Access Compliance Report

Public Rights-of-Way

(Curb Ramps)

Intersection ID: 10034609	Main Street: PLANTATION_CENTER_DR	Cross Street: N/A	Location: NW
ADA ID: C6A1DEE29E68	Ramp Type: Para	Initial Pass/Fail: Fail	Overall Compliance: No
Severity Score: 25			
Codes/Mitigation Info/Possible Solution		Field Measurements/Component Compliance

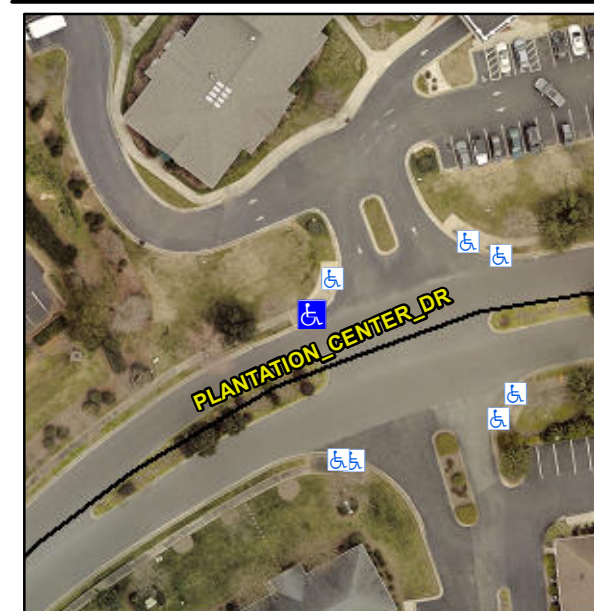
R304.3.2

Compliance	Description	Data	Compliance	Description	Data
N/A	Ramp Length LT (in)	78.0	N/A	Ramp Length RT (in)	60.0
Yes	Ramp Width LT (in)	97.0	Yes	Ramp Width RT (in)	97.0
Yes	Ramp Slope LT (%)	5.6	No	Ramp Slope RT (%)	13.2
Yes	Ramp XSlope LT (%)	1.5	Yes	Ramp XSlope RT (%)	2.0
N/A	Landing Length (in)	N/A	N/A	DWS Provided?	N/A
N/A	Landing Width (in)	N/A	N/A	DWS Contrast?	N/A
N/A	Landing Slope (%)	N/A	N/A	DWS Length (in)	N/A
N/A	Landing X Slope (%)	N/A	N/A	DWS Full Width?	N/A
N/A	Landing Curb? (Y/N)	N/A	N/A	DWS Offset (in)	N/A
N/A	Shared Landing?	N/A			
N/A	Gutter Ponding?	N/A	N/A	Gutter Slope (%)	N/A
N/A	Gutter Lip Ht (in)	N/A	N/A	Gutter X Slope (%)	N/A
N/A	Painted X Walk1?	No	N/A	Painted X Walk2?	N/A
	X Walk 1 Direction	To SE		X Walk 2 Direction	N/A
N/A	X Walk 1 Width (in)	N/A	N/A	X Walk 2 Width (in)	N/A
	X Walk 1 Slope (%)	1.6		X Walk 2 Slope (%)	N/A
	X Walk 1 X Slope (%)	1.7		X Walk 2 X Slope (%)	N/A
N/A	Ramp inside XWalk1?	N/A	N/A	Ramp inside XWalk2?	N/A

Remove & Replace Entire Ramp.
